## New Qualifying Matters

Figure 7: Showing location and PDP zoning of Selwyn Terrace, Hill Street, Portland Crescent and Hawkestone Street

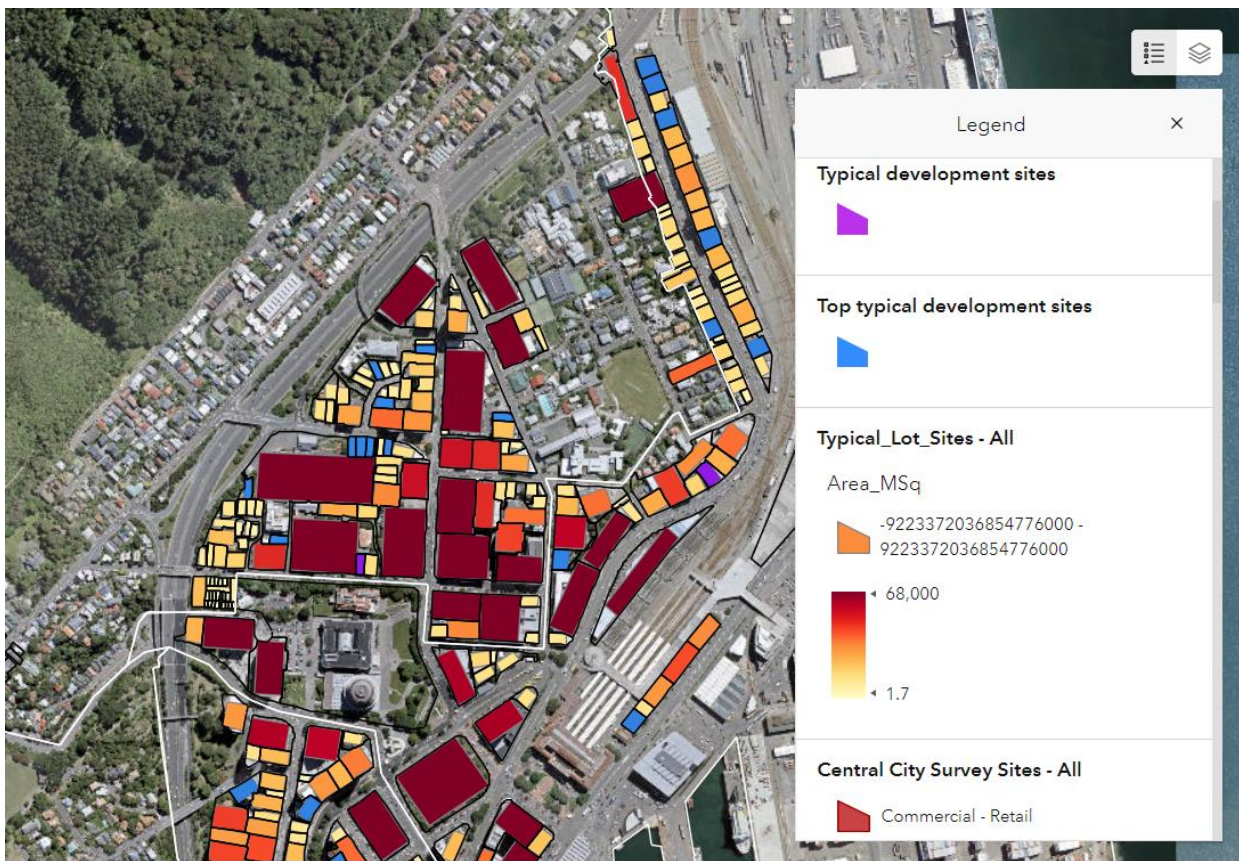
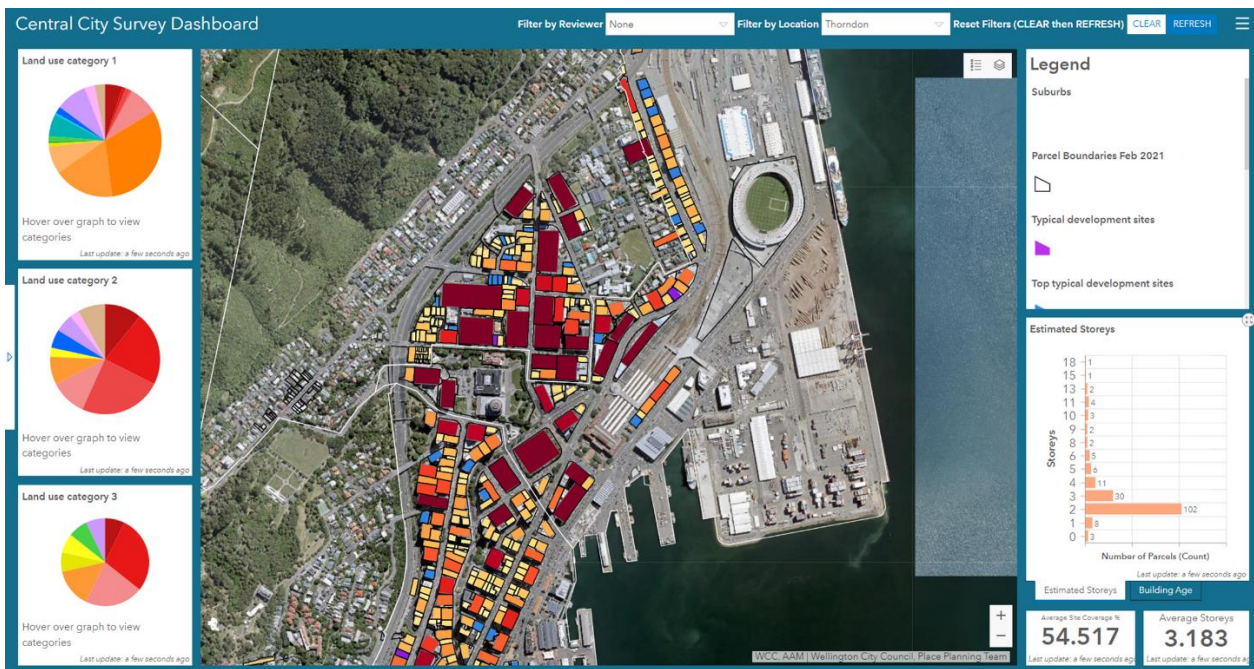
- Figure seven shows the location and zoning of Selwyn Terrace, Hill Street, Portland Crescent and Hawkestone Street area. The motorway acts as a clear physical boundary between the CCZ and residential zones in this part of Thorndon;

- Given the wider area features higher density development, I do not consider it is appropriate to rezone a small pocket of land to HRZ, as this would be out of keeping with the wider area. These areas currently in the ODP adjoin the Central Area and given their location are well-located to support increased densification and opportunities for new housing to meet the city’s growth needs. I appreciate that this area is one of the city’s oldest urban areas, however the NPS-UD directs Council to enable intensification within these areas. This means that even if the area in question is not identified as part of the CCZ, the Council is required to enable ‘at least 6 storey’ development as it sits within a walkable catchment of the edge of the Central City.

Figures 8 and 9: Showing the average lot sizes in Thorndon

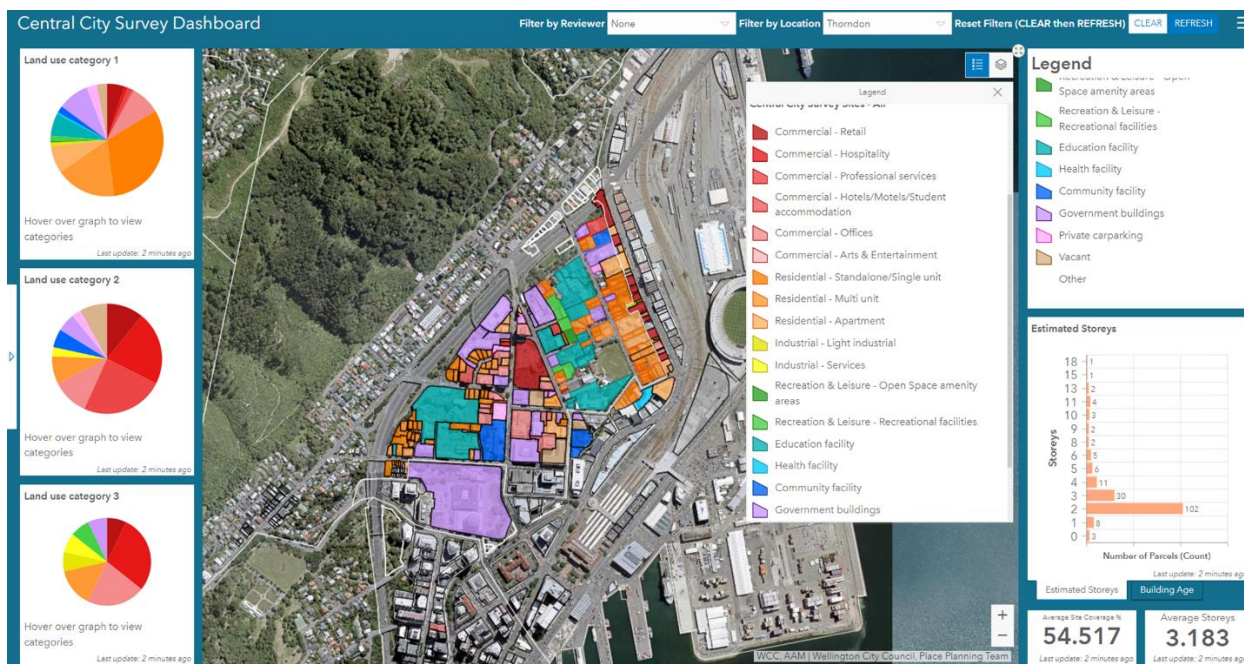
- A mixture of land uses including government, community, education, recreation, commercial and residential. Residential activities took up the top three land uses (in order of standalone/single units, multi-units and apartments) followed by commercial activities (office and then retail).
